MEMORANDUM

SUBJECT: Hawaii Kai Multi-Family (CU2019-0001 / DR2019-0012 / LD2019-0003 / PLA2020-0001 / TP2019-0001) Supplemental Memorandum

Staff is providing the subject memo to make corrections to the Staff Report, dated April 8, 2020, to add findings in response to the Conditional Use criteria, and to incorporate an exhibit provided by the applicant. New language is underlined.

Exhibit 2.1 – Applicant's turning diagram, dated April 15, 2020

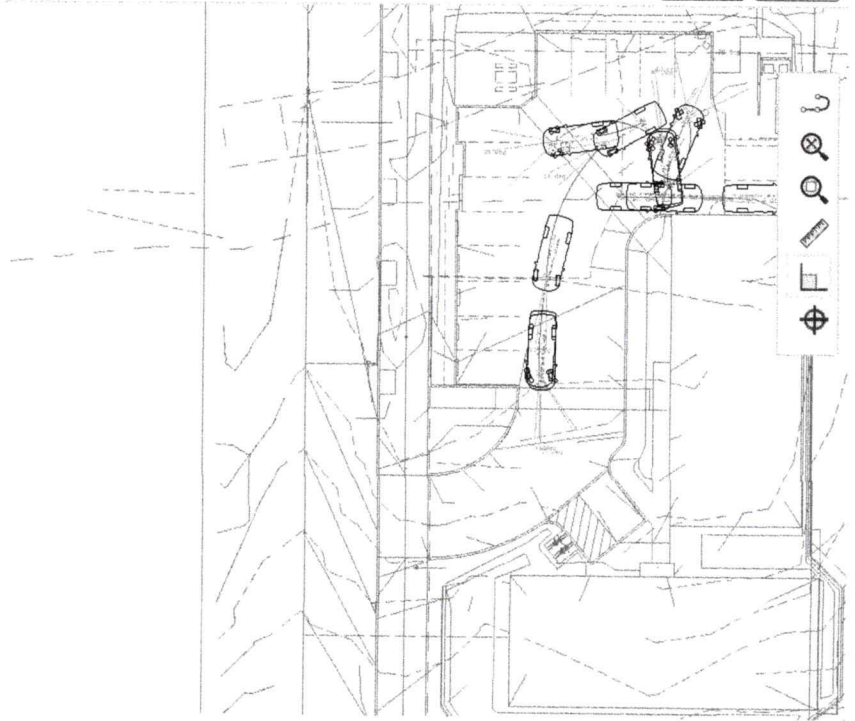
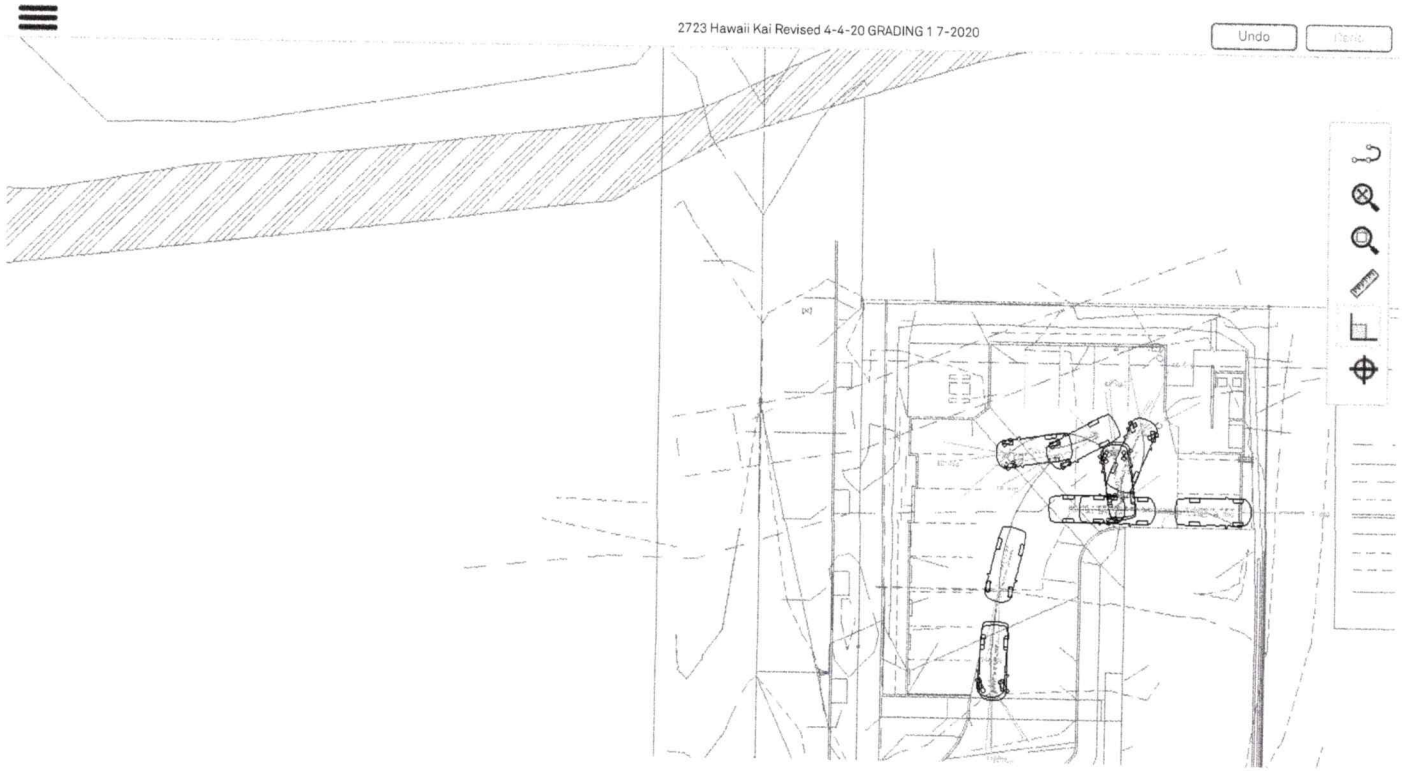
The proposal includes 90-degree parking stalls with a dead end. Drawings provided in Section 60.30.15 of the Development Code outline the parking lot design requirements. Two-way, 90-degree, dead-end parking lots must provide a five-foot deep backing area at the dead-end to allow vehicles to exit the parking lot. The applicant's plans show that the proposed backing area is approximately 3.5 feet in depth and therefore does not meet the standard. Any change from the numerical requirements contained in Section 60.30. (Off-street Parking) are subject to review under the Major Adjustment application, which the applicant has not submitted.

Therefore, staff find the criterion has not been met.
